McDonalds – 517 W 3rd Avenue**1 - Recommendation Meeting**

March 27, 2019

From :
Design Review Board
 Steven Meek, Chair

Figure 1. Expanded Planter Beds

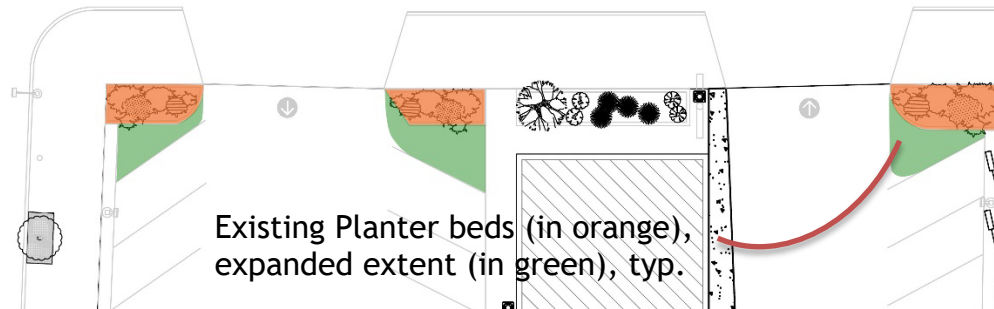
6. The applicant *shall* expand the three modified planter beds at the vehicular ingress/egress lanes along 3rd Avenue onto the site to convert the unused asphalt area adjacent to the existing parking stalls. (See Figure 1)
